Product Change Notification

PRECISION POTENTIOMETERS

Bourns Sensors & Controls Product Line - Model 6639 Product Enhancements

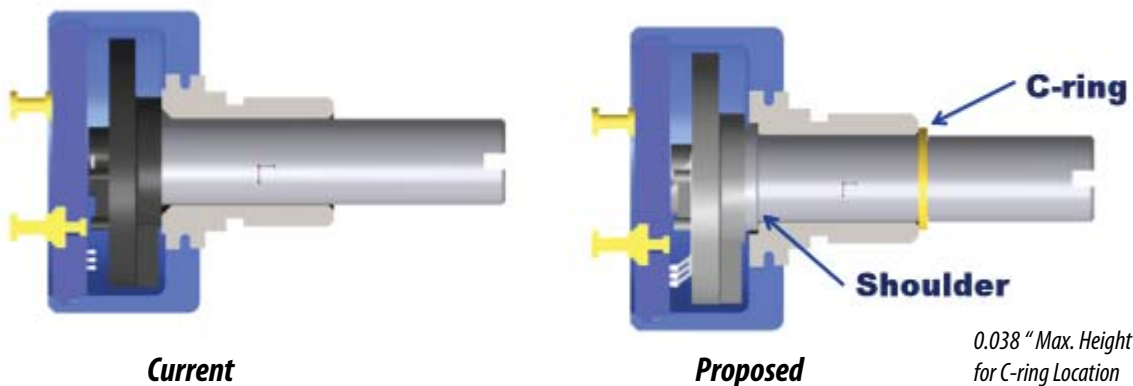
The design enhancements include the addition of a C-ring to help prevent damage that may be induced by excessive axial force applied to the shaft when installing gears or other mechanical devices, and the addition of an internal shoulder to the shaft to better resist shaft pull out from the body if excessive shaft pull force is applied.

Externally, the design enhancements will be recognized by the C-ring that is visible in front of the bushing. The noted enhancements to this product family will have no effect on form or function. Both the new internal shoulder and five-point heat stake of the contact spring will help increase the robustness and reliability of the part. These design enhancements allow the potentiometer to withstand higher axial loads typically encountered on installation or removal of mechanical devices from the shaft. All performance specifications listed on the current data sheet will remain unchanged.
